# PLANNING BOARD REPORT PORTLAND, MAINE

654 Riverside Street, Homeless Services Center  
PL-001682-2021, Major Site Plan and Conditional Use  
DC Predevelopment LLC and City of Portland, Applicant

<b>Submitted to:</b> Portland Planning Board <b>Public Hearing Date:</b> September 14, 2021	<b>Prepared by:</b> Matthew Grooms, Senior Planner <b>Date:</b> September 10, 2021
--	---

Figure 3: Operational Plan highlighting compliance with conditional use standards

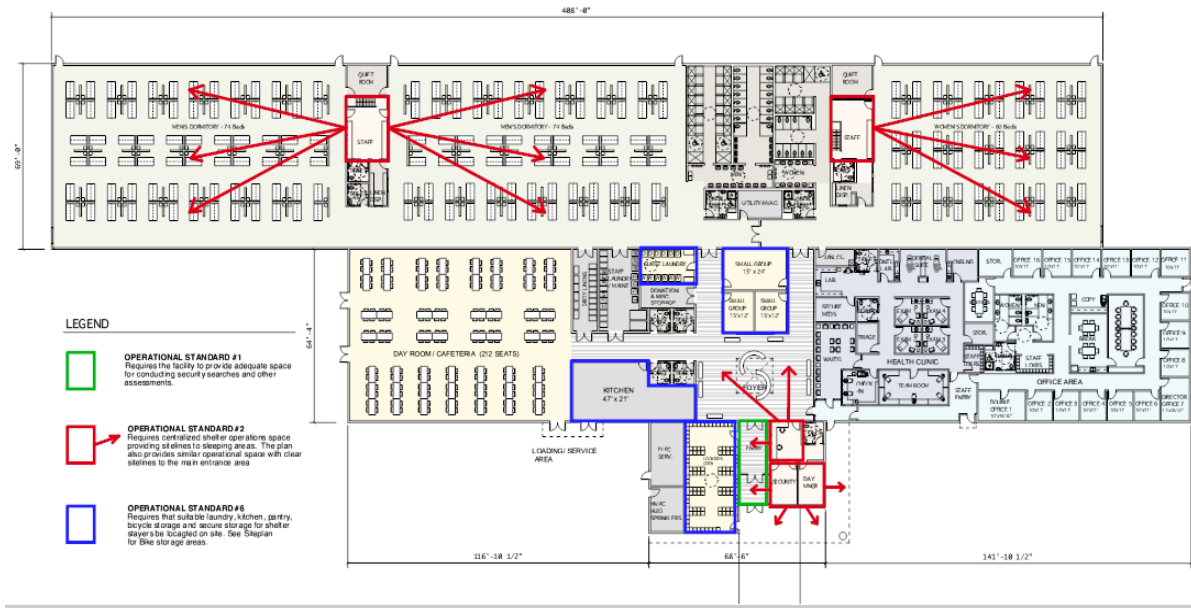
Staff Finding: A dedicated security space is provided within the building’s main vestibule, where guests may be screened and may deposit belongings in a secure locker area also accessible via the main vestibule before entering the facility. This standard is considered met.

Staff Finding: Two separate observation areas are to be developed, where staff will have clear lines of sight to the building’s sleeping and common areas. This standard is considered met. Common areas will further be monitored via CCTV security cameras
